DESIGN <i>DC</i>	DRAWN BY <i>DC</i>	DART AEROSPACE LTD HAWKESBURY, ONTARIO, CANADA	
CHECKED <i>B</i>	APPROVED <i>H</i>	DRAWING NO. DSI 9381	REV. A SHEET 1 OF 1
DATE 07.06.05		TITLE SHOCK ABSORBER SLOT CORRECTION NTS	
A	07.06.05	NEW ISSUE

DART SERVICE INSTRUCTION

TO AMEND INSTALLATION INSTRUCTIONS IIN-D350-748 Rev. A
REF. CANADIAN STC: SH06-27
REF. FAA STC: SR02359NY
REF. EASA STC: IM.R.S.01280

HALF CLAMP INSTALLATION DETAIL ON
D350-748-101 CROSSTUBE.
AS 350/355 HIGH FWD
(VIEW LOOKING FWD)

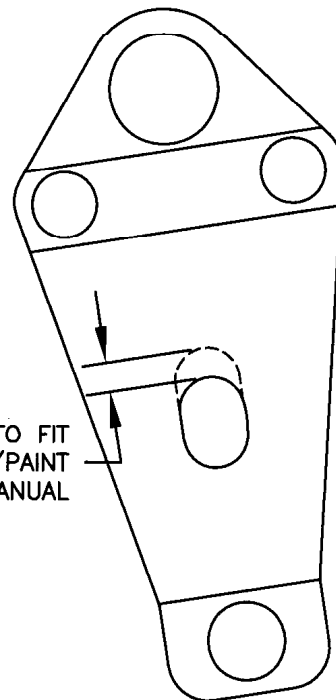
The shock absorber mounting hole on D350-748-101 High Fwd Crosstubes B/N 31013, 31014, 31015, 31016, and 31017 is misaligned with the 350A41-1042-22 Half Clamps.

To correct this situation, it is acceptable to enlarge the slot in the 350A41-1092-22 half clamps as shown. Enlarge slot the minimum amount possible so that bolts will pass through.

Install reworked 350A41-1092-22 Half Clamps (or equivalent) per Installation Instructions IIN-D350-748.

ENLARGE SLOT TO FIT
DEBURR AND TOUCH UP PRIME/PAINT
PER AIRCRAFT MAINTENANCE MANUAL
